## Customer Notification

# QB-V850ESSX2

## In-Circuit-Emulator

## Operating Precautions

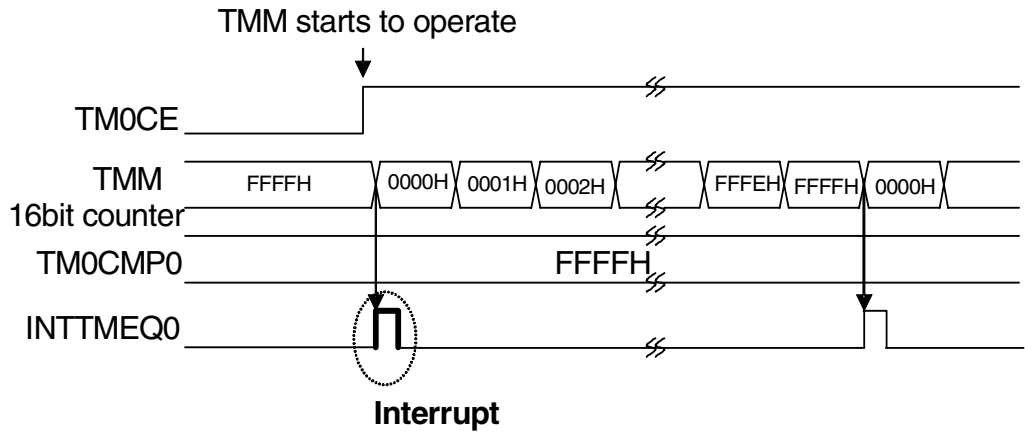
No. 1	Watchdog timer during break (Direction of use)
<p><u>Details</u></p> <p>When both of the following conditions (a) and (b) are fulfilled simultaneously and a break occurs, the watchdog timer does not stop and will cause a reset or non maskable interrupt. If a reset occurs, the debugger hangs up.</p> <p>Conditions that need to be fulfilled so that the above behaviour occurs:</p> <p>(a) The main clock or subclock is selected as the clock source of the watchdog timer and                  (b) The ring oscillator is stopped (RSTOP flag = 1).</p> <p><u>Workaround</u></p> <p>As a workaround to prevent the above behaviour do not stop the ring oscillator clock.</p>

No. 12	DMA transfer forcible termination (Technical limitation)
--------	---

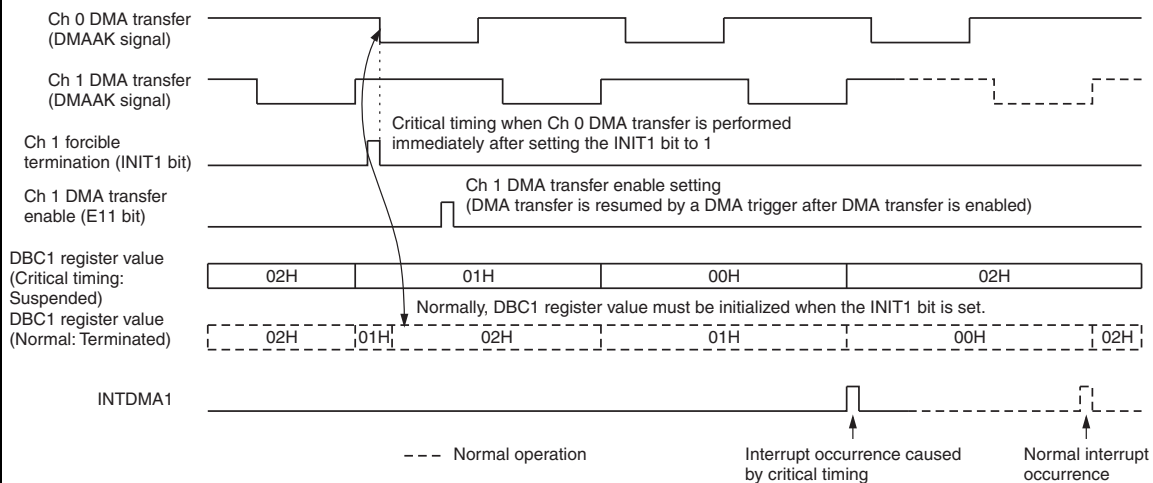
When terminating a DMA transfer by setting the corresponding INITn bit of the DCHCn register, the transfer may not be terminated, but just suspended, even though the INITn bit is set (1). As a result, when the DMA transfer of a channel that should have been terminated is resumed, the DMA transfer will terminate after an unexpected number of transfers are completed and a DMA transfer completion interrupt may occur. In addition, a DMA transfer of a channel n for which the INITn bit is set after forcible termination may be performed once again with the initialized value (n= 0 to 3).

The critical situation occurs if a DMA transfer is executed immediately after a forcible termination is set (by setting the INITn bit), refer to figure below.

The critical timing does not depend on the number of transfer channels, transfer type, transfer target, transfer mode, or trigger, and can occur with any combination of the above elements that can be set under the specifications. In addition, another channel may affect the occurrence of this critical timing.

Operation example: Both DMA channels, ch 0 and ch 1, are in single transfer mode, and ch 1 DMA transfer count is 3 (DBC1 register value = 02H).

No. 12	DMA transfer forcible termination (Technical limitation)
<p>(cont.) <u>Workaround</u></p> <p>The critical situation can be avoided by implementing any of the following procedures.</p> <p><b>&lt;1&gt; Stop all transfers from DMA channels temporarily.</b> The following measure is effective if the program does not assume that the TCn bit of the DCHCn register is 1 except for the following workaround processing. (Since the TCn bit of the DCHCn register is cleared (0) when it is read, execution of the following procedure b) under &lt;5&gt; clears this bit.)</p> <p>Procedure to avoid the critical timing:</p> <ul style="list-style-type: none"> <li>&lt;1&gt; Disable interrupts (DI state)</li> <li>&lt;2&gt; Read the DMA restart register (DRST) and transfer the ENn bit of each channel to a general purpose register (<u>value A</u>).</li> <li>&lt;3&gt; Write 00H to the DMA restart register (DRST) twice<sup>Note</sup>. By executing twice<sup>Note</sup>, the DMA transfer is definitely stopped before proceeding to &lt;4&gt;.</li> <li>&lt;4&gt; Set (1) the INITn bit of the DCHCn register of the channel that should be terminated forcibly.</li> <li>&lt;5&gt; Perform the following operations for value A read in (2) to obtain <u>value B</u>.             <ul style="list-style-type: none"> <li>a) Clear (0) the bit of the channel that is not terminated forcibly.</li> <li>b) If the TCn and ENn bits of the channel that is not terminated forcibly are 1, clear (0) the bit of the channel.</li> </ul> </li> <li>&lt;6&gt; Write value B in &lt;5&gt; to the DRST register.</li> <li>&lt;7&gt; Enable interrupts (EI state)</li> </ul> <p><b>Note:</b> Execute three times if the transfer target (transfer source or transfer destination) is the internal RAM.</p> <p><b>Remarks:</b> 1. Be sure to execute &lt;5&gt; to prevent the ENn bit from being set illegally for channels that are terminated normally during the period of &lt;2&gt; and &lt;3&gt;</p> <p style="padding-left: 40px;">2. n = 0 to 3</p> <p><b>&lt;2&gt; Repeat setting the INITn bit until the forcible DMA transfer termination is correctly performed (n = 0 to 3)</b></p> <p>Procedure to avoid the critical timing:</p> <ul style="list-style-type: none"> <li>&lt;1&gt; Copy the initial transfer count of the channel that should be terminated forcibly to a general-purpose register.</li> <li>&lt;2&gt; Set (1) the INITn bit of the DCHCn register of the channel that should be terminated forcibly.</li> <li>&lt;3&gt; Read the value of the DMA transfer count register (DBCn) of the channel that should be terminated forcibly and compare the value with the one copied in &lt;1&gt;. If the value do not match, repeat &lt;2&gt; and &lt;3&gt;.</li> </ul> <p><b>Remarks:</b> 1. When the DBCn register is read in procedure &lt;3&gt;, the remaining transfer count will be read if the DMA is stopped due to this bug. If the forcible DMA termination is performed correctly, the initial transfer count will be read.</p> <p style="padding-left: 40px;">2. Note that it may take some time for forcible termination to take effect if this workaround is implemented in an application in which DMA transfer other than for channels subject to forcible termination are frequently performed.</p>

No. 15	Pin control with target power OFF (Direction for use)
--------	--

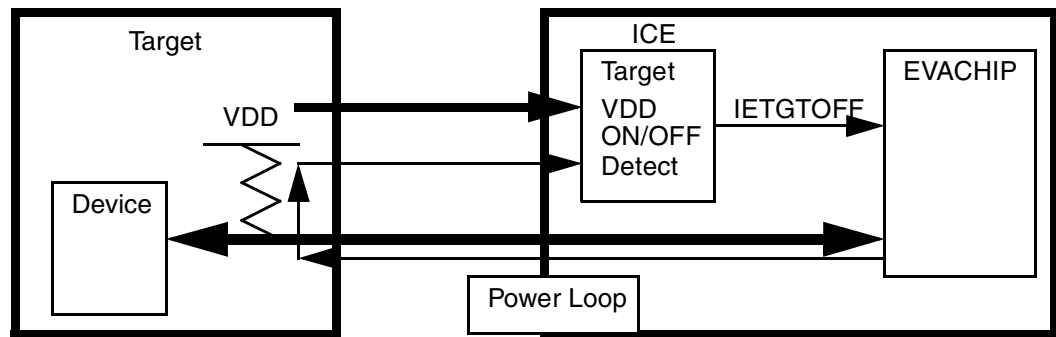
When power to the emulator is ON and that to the target is OFF, leakage current may flow from the emulator to the target.

When the target is connected, the emulator always senses the target supply voltage by using a target supply voltage detector circuit, and the emulator is automatically reset when the target power is turned ON or OFF. In this reset status, the external bus signal go inter a high-impedance state.

Some external bus signals, however, drive a high level, and a current may leak into Vdd of the target via the pull-up resistor of the target.

The target supply voltage detector circuit of the emulator detects this VDD, and the emulator assumes that power is applied to the target. Consequently, reset is cleared and the external bus signals are driven. As a result, a leakage current flows.

Figure 1: Behavior at pending TRQ

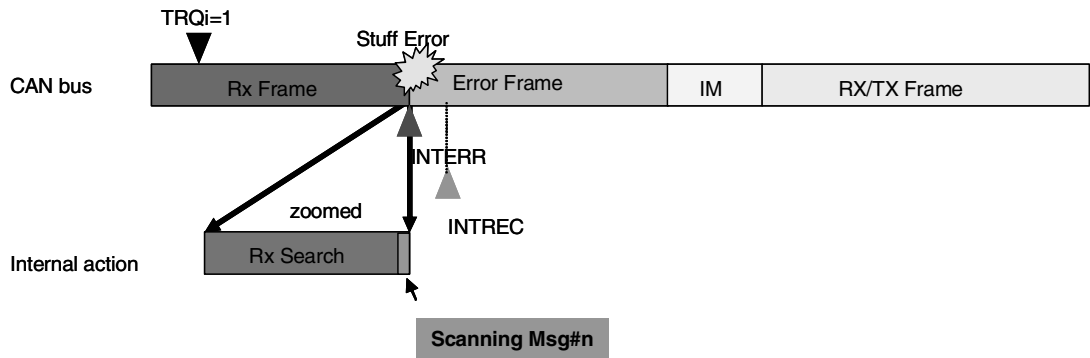
**1. Behaviour at pending TRQ (TRQi = 1)**

When the host processor has already submitted a transmit request (TRQ) for at least one buffer, the unexpected reception of the message will take place into the message buffer found by internal RX-search. This is the correct location to store the message i.e. the acceptance filter criteria are correctly fulfilled. However the data part will be updated with the contents of the shift register of the CAN protocol core. As this register is immediately stopped at detection of the bus error, the data provided to the message buffer can not be interpreted by the host processor.

As during a regular reception, the RX-interrupt (if enabled) is generated and the application processes the message object.

No. 38	aFCAN: Rx limitation (Technical limitation)
<p>(cont.)</p> <p><u>Workaround</u></p> <p>NEC will update the affected products. NEC does not recommend a S/W workaround as first choice as it is fairly complex. On the one hand it is based on the control of submitting transmission requests only when the bus is idle. On the other hand a less complex algorithm can be used which does not prevent the unexpected reception but detects it safely and discards the unexpected reception in the CAN S/W driver. Any of these algorithms require that message buffer #0 is not used or that a 'dummy' TRQ in an unused buffer is set. This prevents behaviors as described in 2.</p>

Figure 2: Behavior without pending TRQ

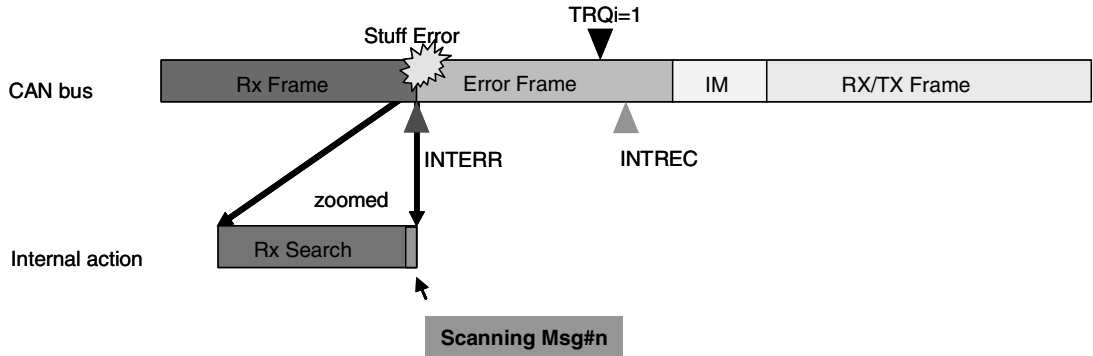
**2. Behavior without pending TRQ (TRQi = 0)**

In case the host processor has not submitted a transmit request (TRQ) for any buffer before the detection of the bus error but submits TRQ = 1 after that point in time (see figure below) before the re-transmission of the message interrupted by the stuff bit error started, the unexpected reception of the message will take place.

The unexpected storage of the message is issued in the particular message buffer that matches the acceptance filter criteria at the time where the bus error is detected (as described in 1.) or the message buffer #0 is overwritten independently of its configuration.
